Service Bulletin No. 426

MODEL	J4500 Series	TYPE	Field Change Program	SECTION/GROUP	8-Engine	DATE	June 10, 2015
SUBJECT	COOLANT SENSOR						
CONDITIONS

Figure 1.

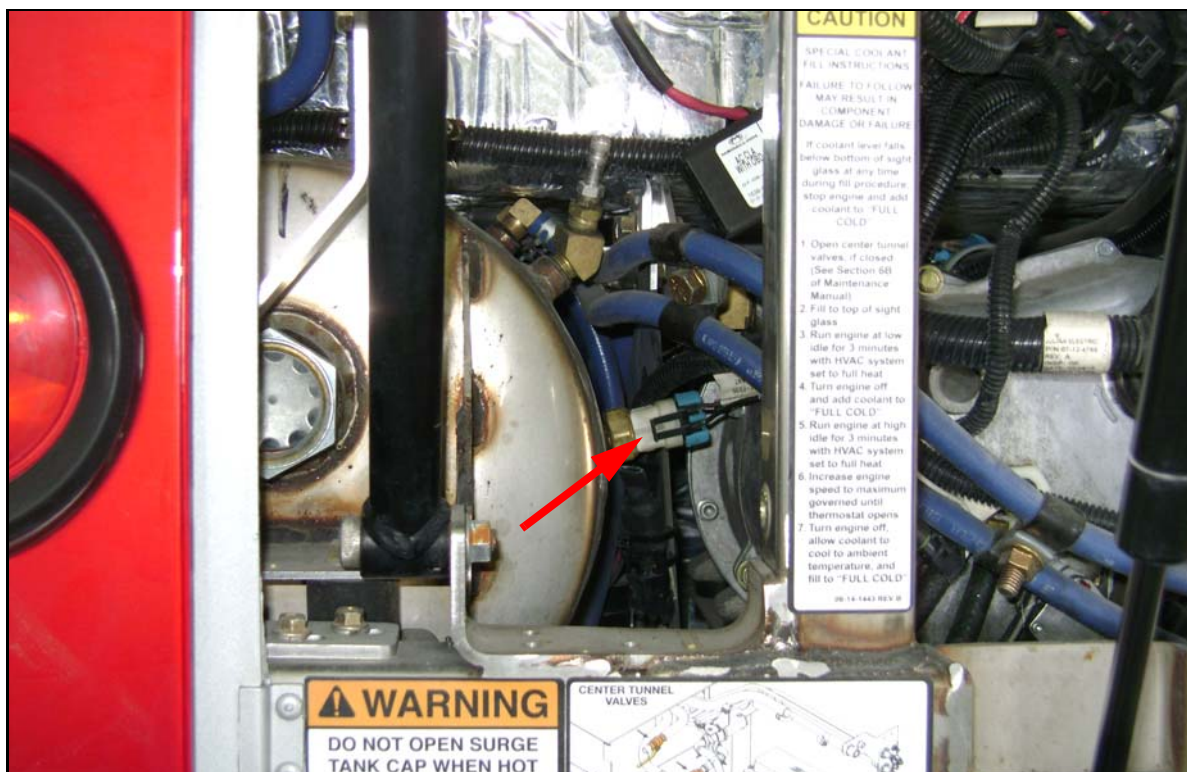
1. Open the engine door. Position the ENGINE RUN and ENGINE START switches on the engine compartment remote control box to the OFF position.
2. Chock both sides of the tires.
3. Using a clean, suitable sized container, drain the coolant to the bottom of the sight glass (refer to Figure 1).
4. Locate the coolant sensor in the upper, roadside of the engine compartment (refer to Figure 1).
